UNITED STATES PATENT AND TRADEMARK OFFICE

APPLICATION NO.	FILING DATE	FIRST NAMED INVENTOR	ATTORNEY DOCKET NO.	CONFIRMATION NO.
10/709,607	05/18/2004	Ping-Yang Chen	12590-US-PA	3606
31561 7590 05/08/2007 JIANQ CHYUN INTELLECTUAL PROPERTY OFFICE 7 FLOOR-1, NO. 100 ROOSEVELT ROAD, SECTION 2 TAIPEI, 100 TAIWAN			EXAMINER WU, IVES J	
			ART UNIT 1724	PAPER NUMBER
			NOTIFICATION DATE 05/08/2007	DELIVERY MODE ELECTRONIC

Office Action Summary

DETAILED ACTION

FIG 3A

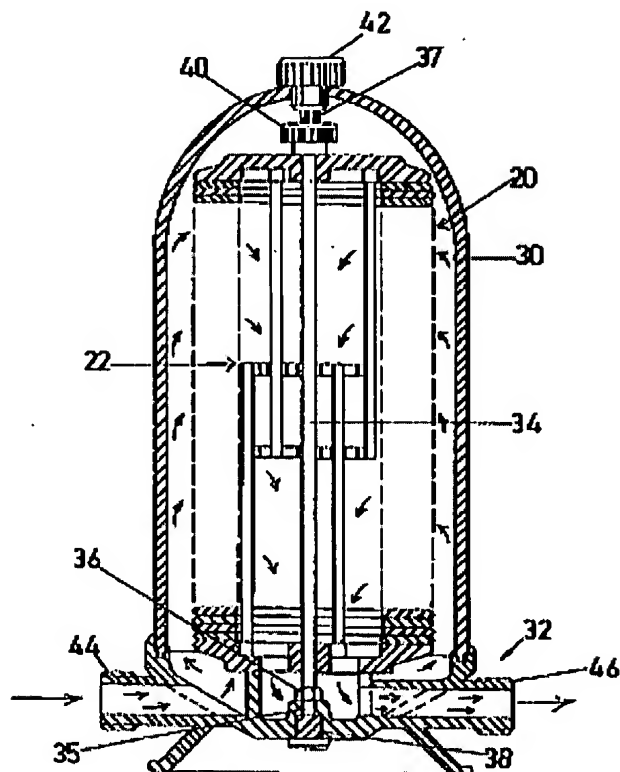
As to a gas inlet, a gas outlet and a hollow interior in a pipe trap body in **independent claim 1**, Drori (US004642182) discloses multiple-disc type filters in a housing shown in Figure 3A, a liquid inlet 44, a liquid outlet 46 and hollow interior between the housing 30 and filtration unit 20.

As to a disc filter set up inside the pipe trap body in **independent claim 1**, Drori discloses multiple disc filter 20 in Figure 3A.

As to a pipe setup inside the pipe trap body with one end linked to the disc filter and the other end linked to the gas outlet, an area on the pipe facing the gas inlet in **independent claim 1**, Drori discloses in Figure 3A, (no number) a section facing the inlet 44 which connects to disc filtration unit 20 at one end, and its other end connects to the outlet 46.

As to limitation of **claim 2**, Drori discloses the base 32, tube body set up on the base such as filtration unit 20 and respective end members, inlet 44, outlet 46 formed on the tube body in Figure 3A.

As to limitation of **claim 3**, Drori discloses the inlet 44 on one side of the housing 30, the outlet 46 is on the other side of the housing, also on the base surface of the housing in Figure 3A. Strauss also discloses outlet 76 on the top surface of the body in Figure 2.

As to limitation of **claim 4**, Drori discloses a central securing rod 34 in Figure 3A set up in the base 32 to mount all filters including mesh separator when the teaching of Strauss is combined.

FIG 2

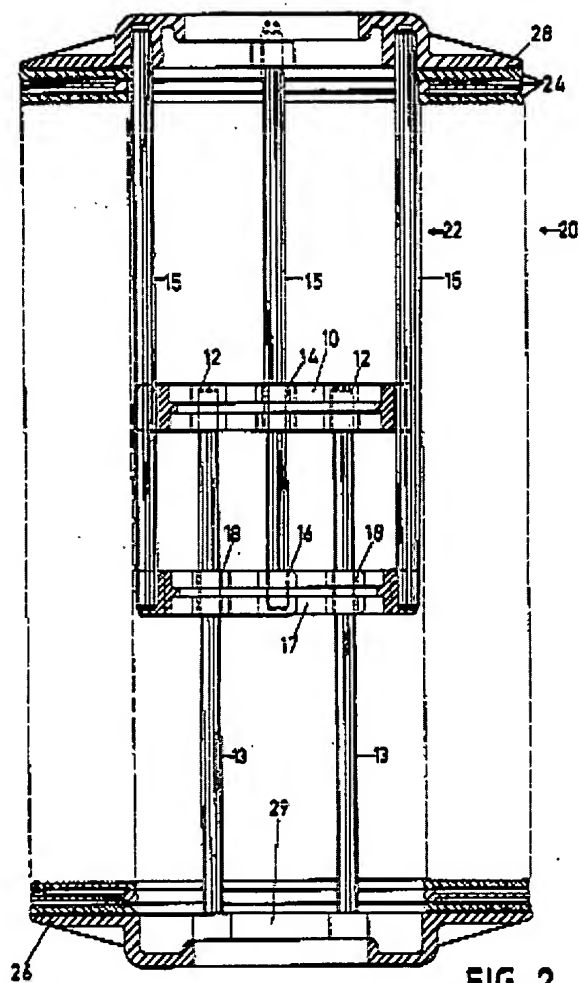
As to the disk filter comprising a plurality of ring-shaped discs stacked up on the base with the pipe set up on top of the disc filter in **independent claim 1**, as shown in Figure 2, a stack of annular filter disk 24 is supported on the stack support 22, 1st and 2nd end elements 26 and 28 are rigidly attached to the free ends of respective rods 13 and 15 (Col. 3, line 26-31).

As to the gaseous exhaust entering the pipe trap from inlet, passing through the outer wall of the pipe into the disc filter interior, and traveling through the mesh filters sequentially before emerging from pipe trap via the gas outlet in **independent claim 1**, Drori discloses in the Figure 2 by arrowing the directions of the flow that includes flow entering the pipe trap, passing through outer wall of the pipe into disc filter interior, and traveling through the mesh filters sequentially before the outlet when the teaching of Strauss is combined.

Figure 2

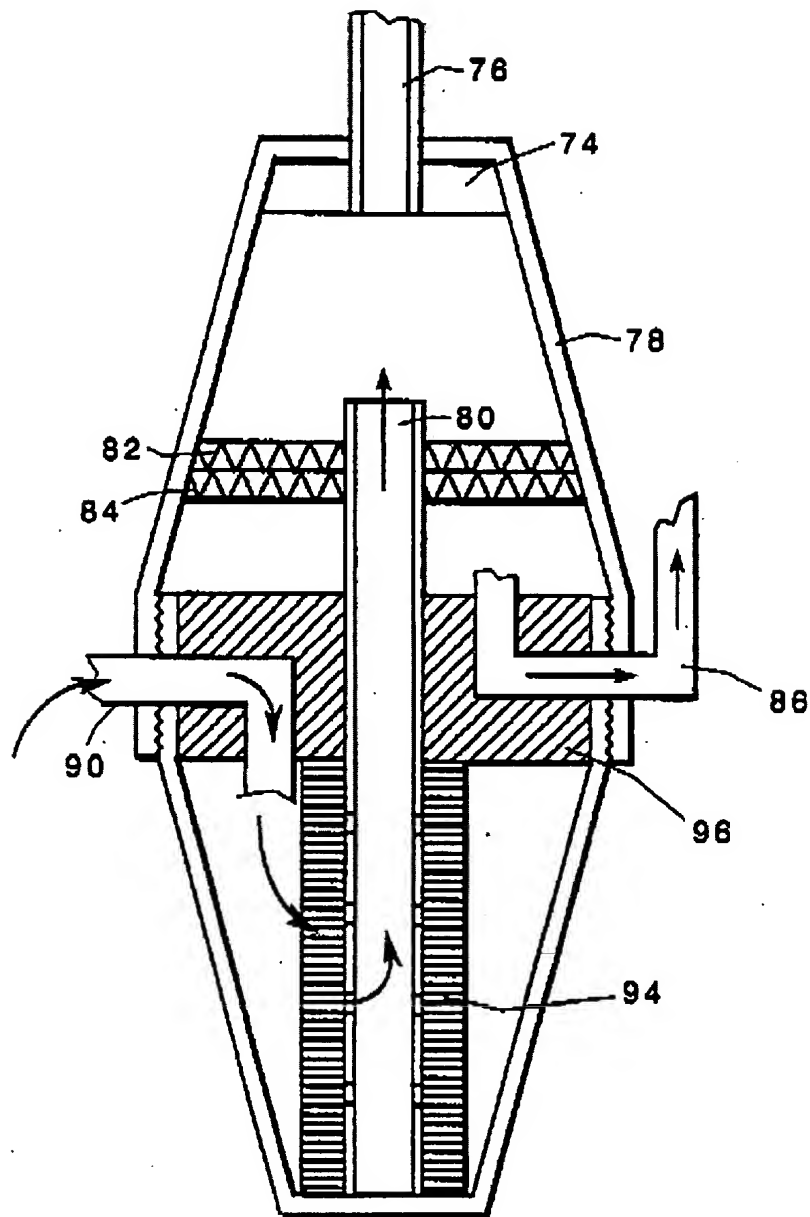
However, Strauss (US005401404) teaches the plastic mesh separator 82 and 84 in Figure 2 in the outlet.

The advantage of adding the mesh separator in the outlet area is to assist to further remove impurity such as oil in the patentee's application.

Therefore, it would have been obvious at time of the invention was made to install further mesh filters of Strauss in the outlet of housing disclosed by Drori in order to obtain the above-mentioned advantage.

As to limitation of **claim 16**, although Strauss does not disclose that different mesh size for 82 and 84 and decreasing mesh size toward the outlet in Figure 2, however, it is well known in the art to arrange the decreasing mesh size filters in the direction of output to get better separation. Therefore, it would have been obvious at time of the invention to put different mesh

size filters taught by Strauss with decreasing size toward the outlet such as the mesh size of 82 to be smaller than the mesh size of 84 in the outlet of Drori in order to obtain the above-mentioned advantage.
